SI M54 04 17
Special Roofs

SERVICE ACTION: REWORKING THE SOFT TOP BOW BEARING

F57 (Cooper, Cooper S, JCW Convertible)			
---	--	--	--

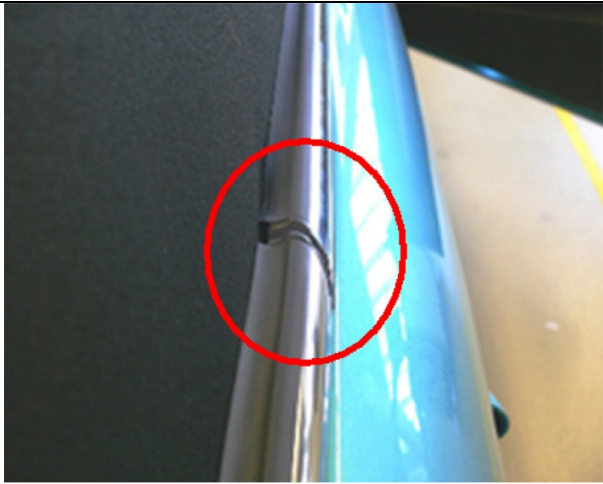
The adjusting element interferes with the soft top and it may or may not cause chafing of the convertible top fabric at the c-pillar area as shown below.

The adjusting element installed in the soft-top bow bearing support may come into contact with the soft top.

Replace the adjusting element with an improved part.
